**SECTION 00 91 01
ADDENDUM NUMBER 1**

DATE: **AUGUST 12, 2021**

PROJECT: **CITY OF AURORA - WILDER PARK PROMENADE PAVILION FACILITY
350 N. RIVER STREET
AURORA, ILLINOIS 60506**

PROJECT NO: **19-130-1277**

A700

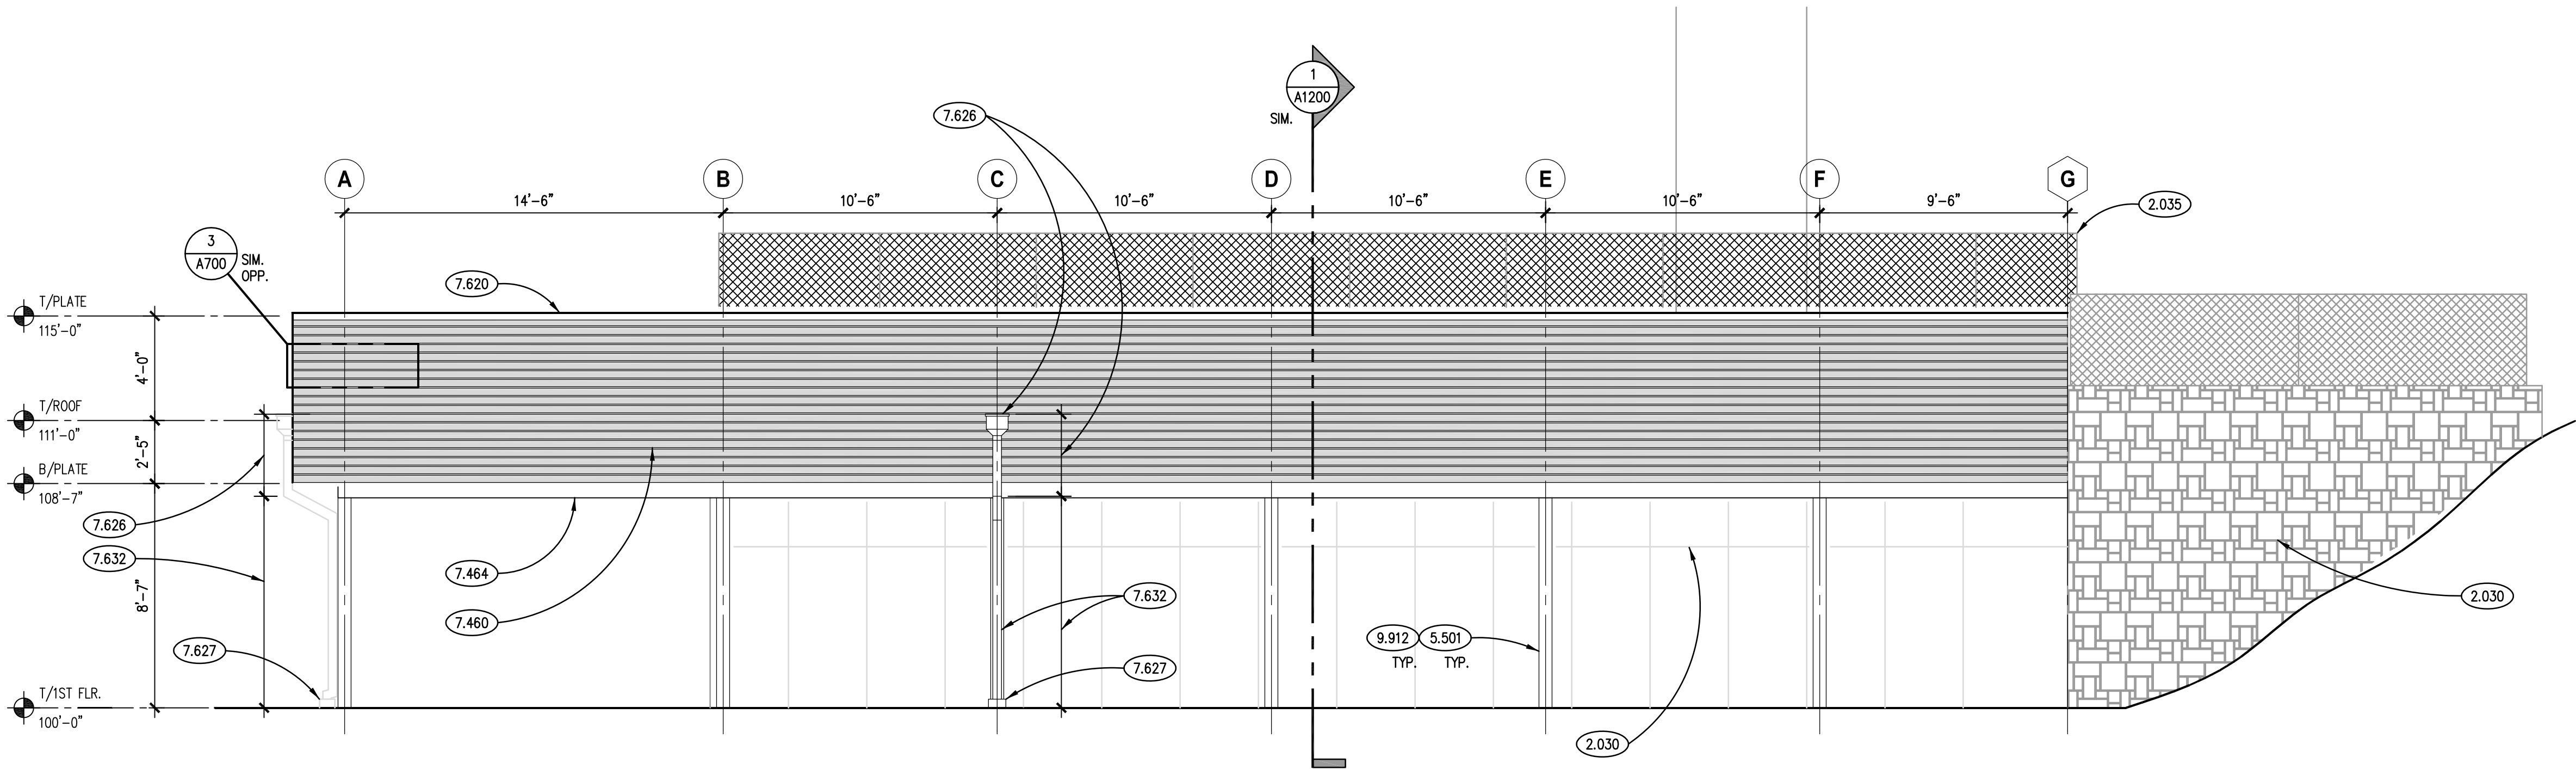
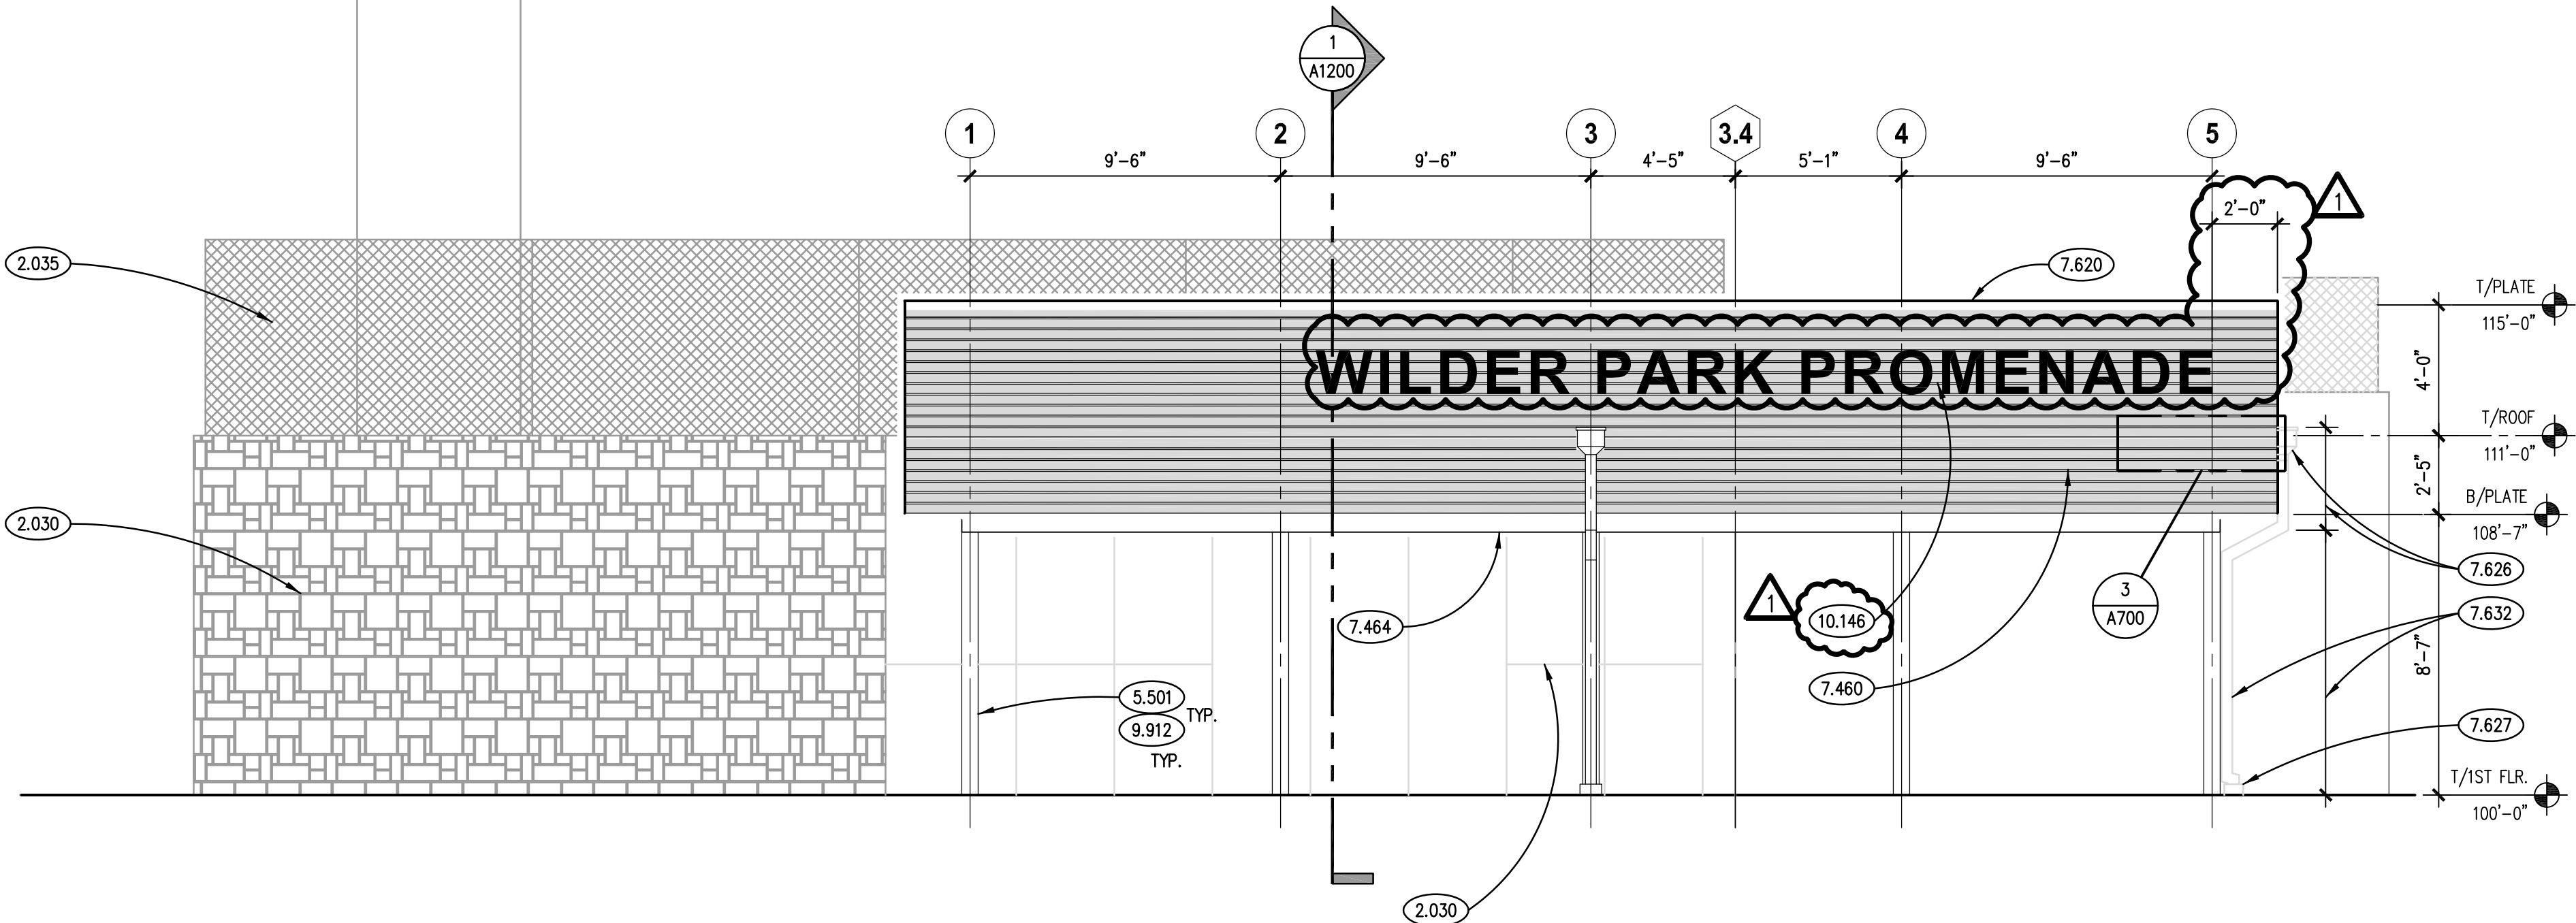
A. Delete this Drawing and replace with revised Drawing A700 (attached). Refer to revision cloud 1.
